Response to WSCC Comments

Denhams,
Stane Street,
Billingshurst,
RH14 9JT

- 1.1 This Transport Technical Note has been prepared in response to comments received from West Sussex County Council (WSCC) on planning application DC/25/1108 (14/08/2025), which proposes the construction of 1 no. detached dwelling and 2 no. semi-detached dwellings.
- 1.2 WSCC has requested further evidence to confirm that visibility from the proposed access is sufficient, particularly in relation to the road alignment to the north. The WSCC comments are include in Appendix A.

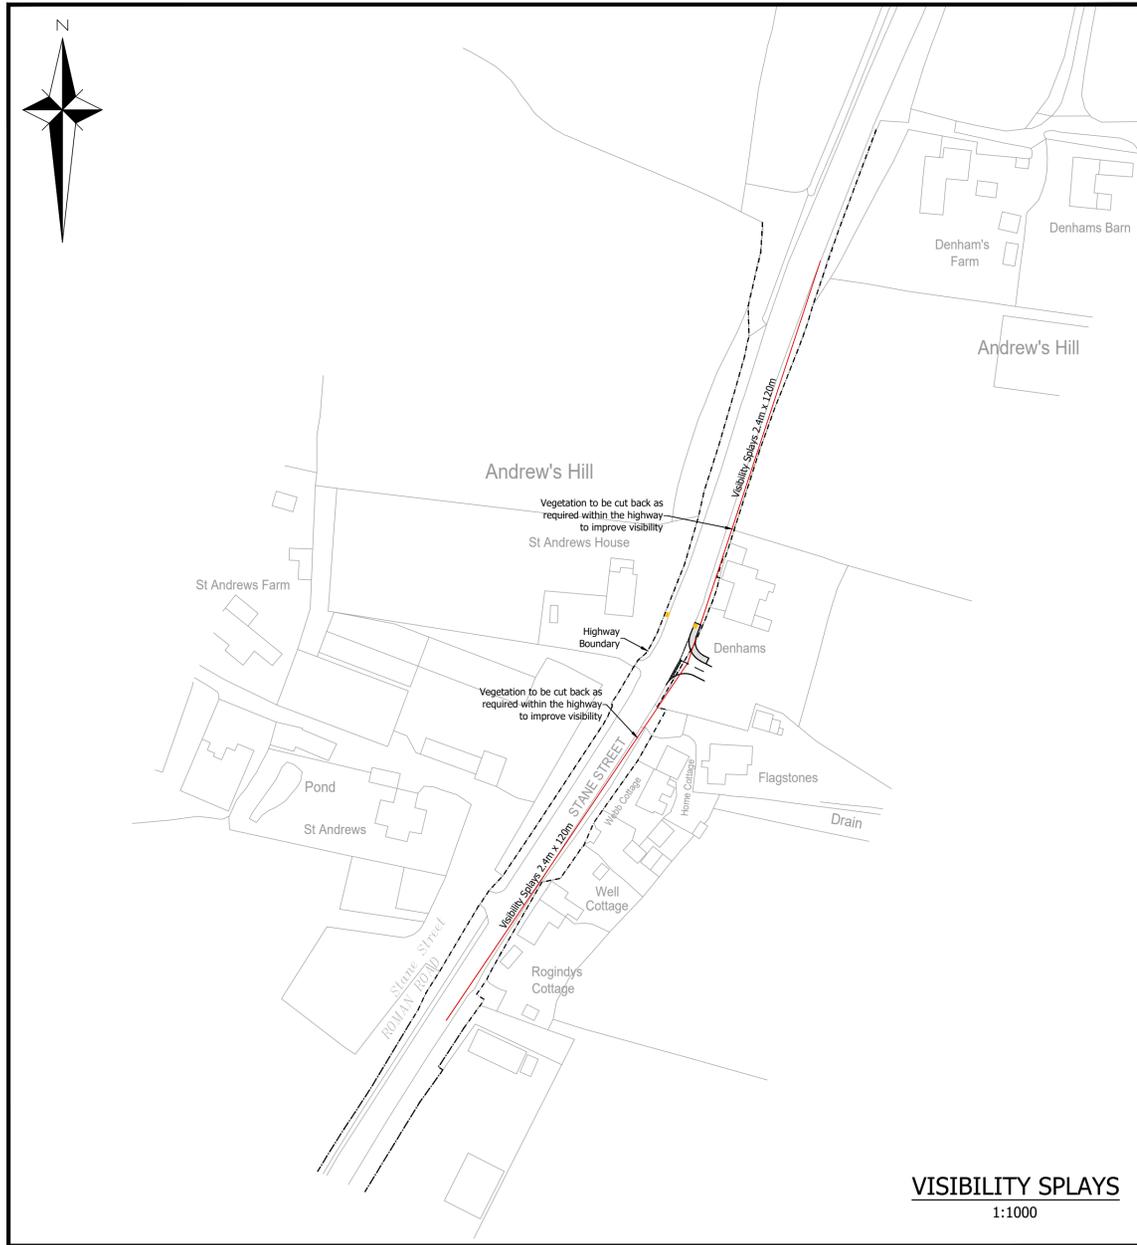
A new vehicle access point is proposed on Stane Street to serve the development. Visibility splays of 2.4m x 160m have been demonstrated in both directions for the proposed access point.

The Transport Statement includes the results of a seven-day speed survey, which found the 85th percentile speeds to be 54 mph in both directions. This would therefore warrant visibility splays of 167m to be provided, as per Design Manual for Roads and Bridges (DMRB) parameters.

In addition to the above, I note that the demonstrated visibility splay to the north of the proposed access point may be obstructed by the brow of the hill, due to the alignment of the road in this direction. I would request that visibility be demonstrated based on what a driver's eye would realistically see. It would be useful to determine the forward visibility of cars travelling down the road toward the site.

- 1.3 Stane Street has recently been subject to a speed limit reduction to 40mph, which requires visibility splays of 2.4m x 120m in both directions. Photographic evidence taken from the proposed access point demonstrates that visibility is adequate in both the northern and southern directions. This confirms that the proposed access meets the necessary highway safety standards. The access plan has been updated to demonstrate the 2.4m x 120m splays and is attached in Appendix B.
